Access Compliance Report

Public Rights-of-Way

(Curb Ramps)

Intersection ID: 14314	Main Street: E_TREMONT_AV	Cross Street: SOUTH_BV	Location: NE
ADA ID: 3EF13556D1CB	Ramp Type: Perp	Initial Pass/Fail: Fail	Overall Compliance: No
Severity Score: 13.75			
Codes/Mitigation Info/Possible Solution		Field Measurements/Component Compliance

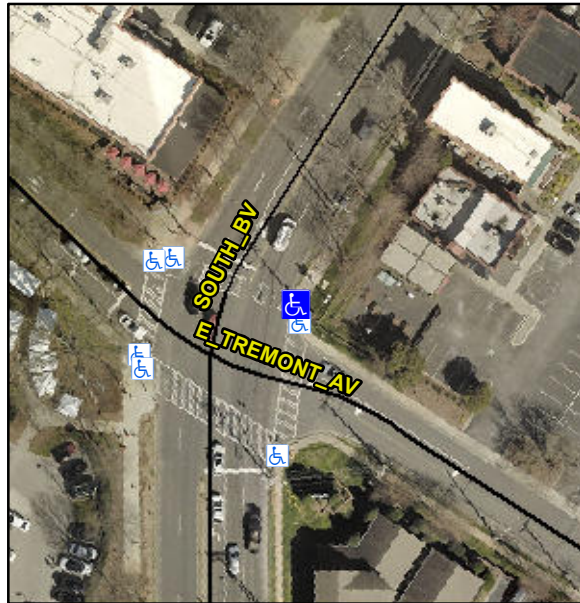
R304.2.2, R304.5.3

Compliance	Description	Data	Compliance	Description	Data
N/A	Ramp Length (in)	60.0	No	Ramp Slope (%)	9.6
Yes	Ramp Width (in)	48.0	No	Ramp XSlope (%)	2.8
N/A	Flare Type LT	N/A	N/A	Flare Type RT	N/A
N/A	Flare Slope LT (%)	N/A	N/A	Flare Slope RT (%)	N/A
N/A	Flare Traversable LT?	N/A	N/A	Flare Traversable RT?	N/A
N/A	Landing Length (in)	N/A	N/A	DWS Provided?	N/A
N/A	Landing Width (in)	N/A	N/A	DWS Contrast?	N/A
N/A	Landing Slope (%)	N/A	N/A	DWS Length (in)	N/A
N/A	Landing X Slope (%)	N/A	N/A	DWS Full Width?	N/A
N/A	Landing Curb? (Y/N)	N/A	N/A	DWS Offset (in)	N/A
N/A	Shared Landing?	N/A			
N/A	Gutter Ponding?	N/A	N/A	Gutter Slope (%)	N/A
N/A	Gutter Lip Ht (in)	N/A	N/A	Gutter X Slope (%)	N/A
N/A	Painted X Walk1?	Yes	N/A	Painted X Walk2?	N/A
	X Walk 1 Direction	To NW		X Walk 2 Direction	N/A
N/A	X Walk 1 Width (in)	113.0	N/A	X Walk 2 Width (in)	N/A
	X Walk 1 Slope (%)	4.8		X Walk 2 Slope (%)	N/A
	X Walk 1 X Slope (%)	1.0		X Walk 2 X Slope (%)	N/A

Remove & Replace Entire Ramp.
